NUREG-0635

Generic Evaluation of Feedwater Transients and Small Break Loss-of-Coolant Accidents in Combustion Engineering Designed Operating Plants

Office of
Nuclear Reactor Regulation

U.S. Nuclear Regulatory
Commission

Auxiliary Feedwater System
St. Lucie, Unit 1
Figure 1

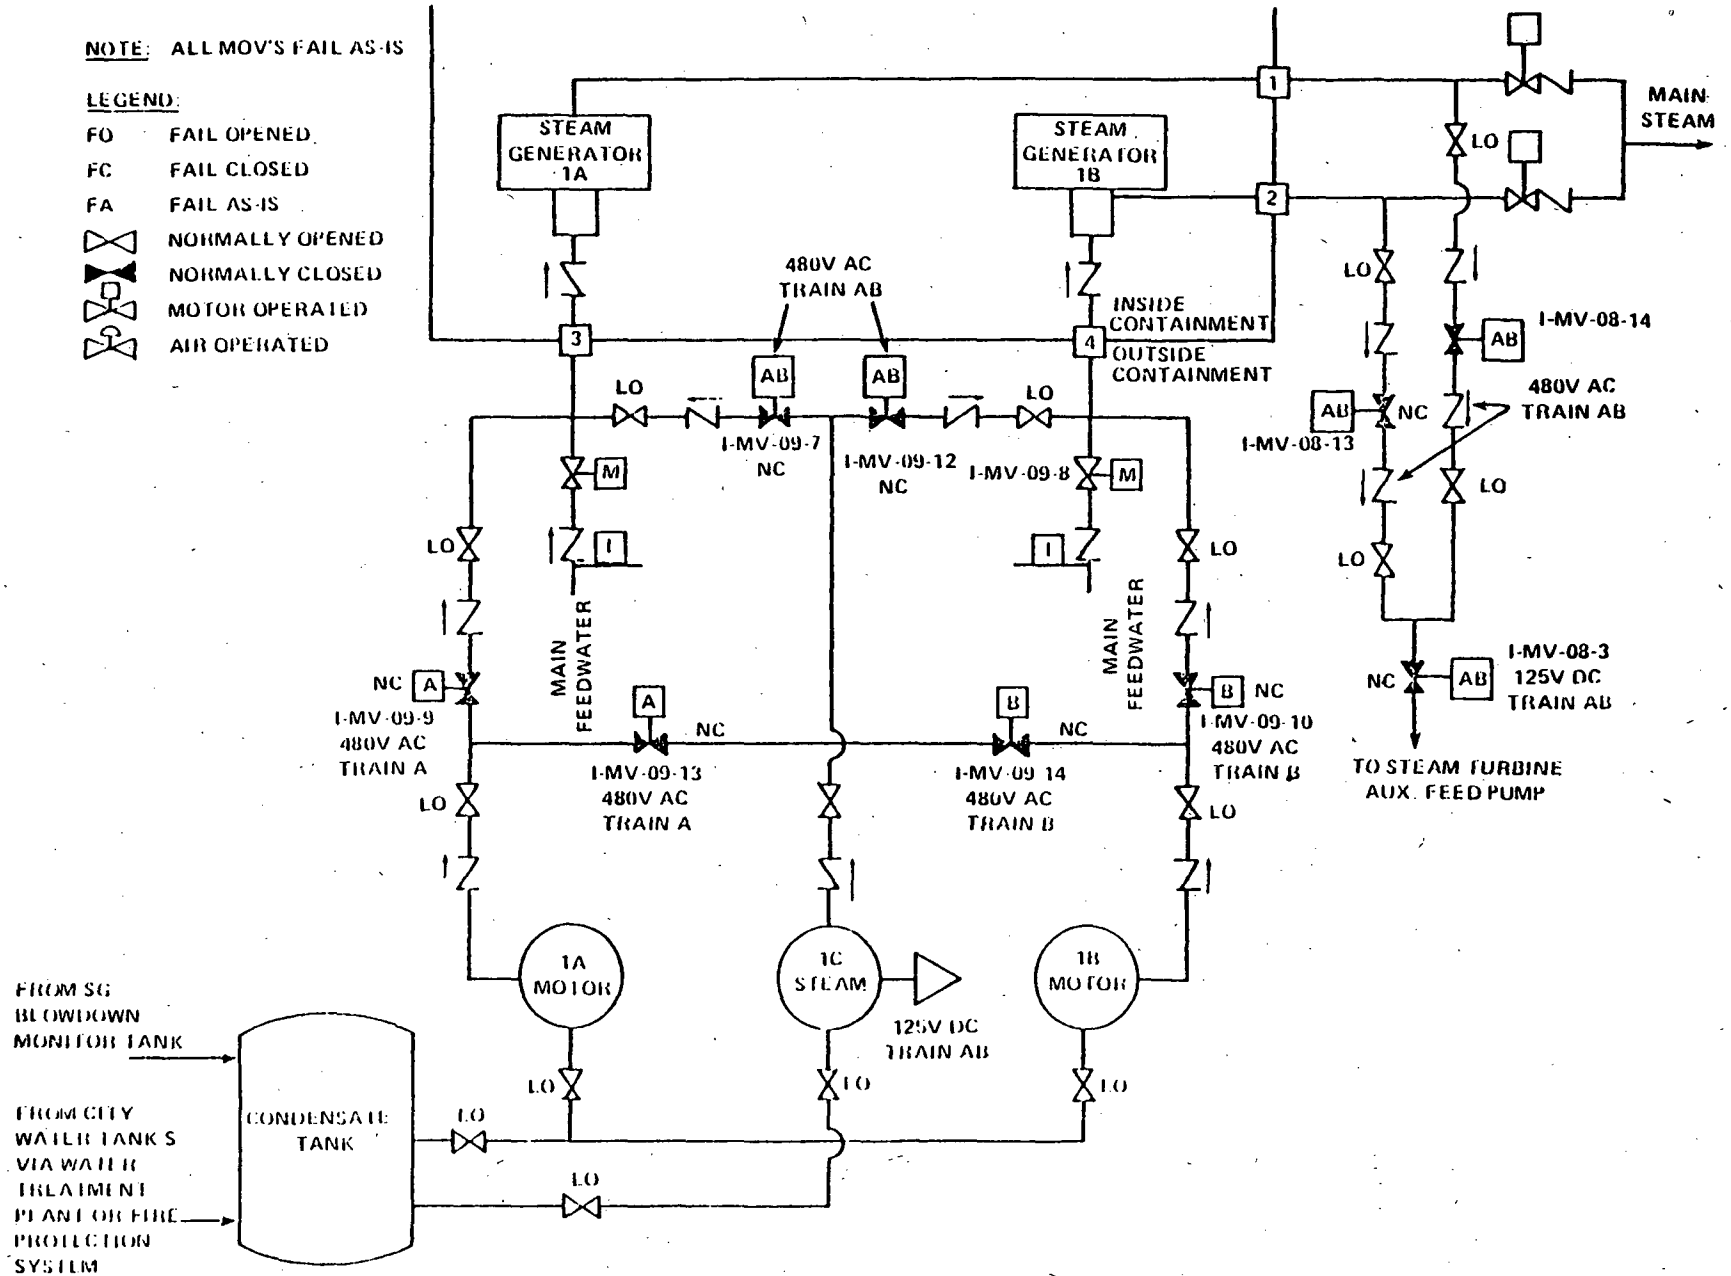
3. Recommendation - The present method of supplying water from the alternate water sources to the CST for the AFWS requires considerable operator action and is estimated to take approximately three hours to accomplish. The licensee should modify the design to provide means to supply water to the AFWS from the alternate sources within one-half hour or less.

4. Recommendation - The St. Lucie plant needs one full capacity train of AFW flow (2 motor-driven or 1 turbine-driven AFW pump) for safe plant shutdown. This AFWS design does not meet the high energy line break criteria in SRP 10.4.9 and Branch Technical Position 10-1; namely that the AFWS should maintain the capability to supply the required AFW flow to the steam generator(s) assuming a pipe break anywhere in the AFW pump discharge lines plus a single active failure. The licensee should (1) complete an evaluation assuming such an event and determine any AFW system modifications or procedures necessary to maintain the required AFW flow to the steam generator(s), or (2) describe how the plant can be brought to a safe shutdown condition by use of other available systems following such a postulated event.
